PCN# : P3B2A

Issue Date : Feb. 11, 2014

DESIGN/PROCESS CHANGE NOTIFICATION

To correct marketing drawing heat sink width SPEC from 15.40mm~15.80mm to 15.40mm~16.20mm. (refer to MOD#MKT-TO3P03A)

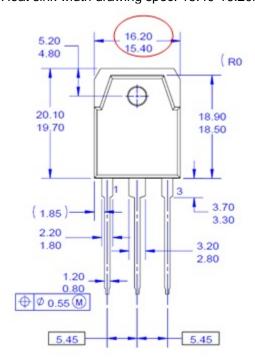
Description of Change (From):

Heat sink width drawing spec: 15.40-15.80mm

Description of Change (To) : Heat sink width drawing spec: 15.40-16.20mm

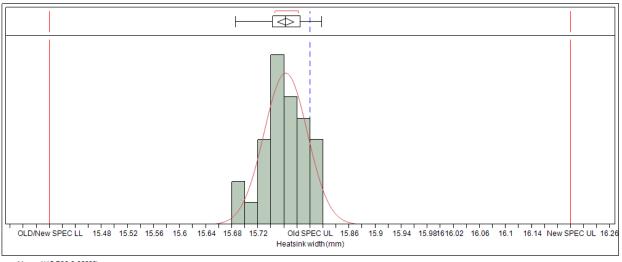
Average value of raw heat-sink width data(mm)		
Stdev of Heat-sink width data(mm)		
Old Heat-sink width criteria LSL(mm)		
Old Heat-sink width criteria USL(mm)		
New Heat-sink width criteria LSL(mm)		
New Heat-sink width criteria USL(mm)		
CPK base on old heat-sink width criteria		
CPK base on new heat-sink width criteria
